Access Compliance Report

Public Rights-of-Way

Intersection ID: 50239	Main Street: EVERGREEN TERRACE DR	Cross Street: LONGSTONE LN	Location: W
ADA ID: 89FB60E2BE52	Ramp Type: Perp	Initial Pass/Fail: Fail	Overall Compliance: No
Severity Score: 12.5			
Codes/Mitigation Info/Possible Solution		Field Measurements/Component Compliance

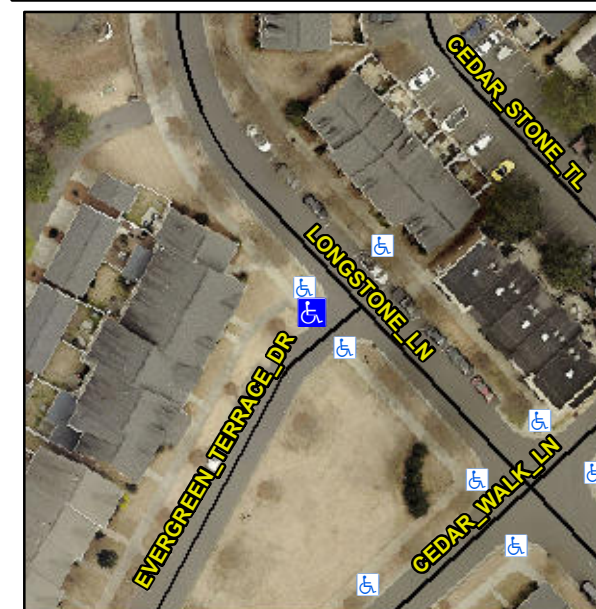
R304.2.2

Compliance	Description	Data	Compliance	Description	Data
N/A	Ramp Length (in)	44.0	No	Ramp Slope (%)	10.1
Yes	Ramp Width (in)	48.0	Yes	Ramp XSlope (%)	1.3
N/A	Flare Type LT	N/A	N/A	Flare Type RT	N/A
N/A	Flare Slope LT (%)	N/A	N/A	Flare Slope RT (%)	N/A
N/A	Flare Traversable LT?	N/A	N/A	Flare Traversable RT?	N/A
N/A	Landing Length (in)	N/A	N/A	DWS Provided?	N/A
N/A	Landing Width (in)	N/A	N/A	DWS Contrast?	N/A
N/A	Landing Slope (%)	N/A	N/A	DWS Length (in)	N/A
N/A	Landing X Slope (%)	N/A	N/A	DWS Full Width?	N/A
N/A	Landing Curb? (Y/N)	N/A	N/A	DWS Offset (in)	N/A
N/A	Shared Landing?	N/A			
N/A	Gutter Ponding?	N/A	N/A	Gutter Slope (%)	N/A
N/A	Gutter Lip Ht (in)	N/A	N/A	Gutter X Slope (%)	N/A
N/A	Painted X Walk1?	No	N/A	Painted X Walk2?	N/A
	X Walk 1 Direction	To SE		X Walk 2 Direction	N/A
N/A	X Walk 1 Width (in)	N/A	N/A	X Walk 2 Width (in)	N/A
	X Walk 1 Slope (%)	0.8		X Walk 2 Slope (%)	N/A
	X Walk 1 X Slope (%)	1.0		X Walk 2 X Slope (%)	N/A

Remove & Replace Entire Ramp.
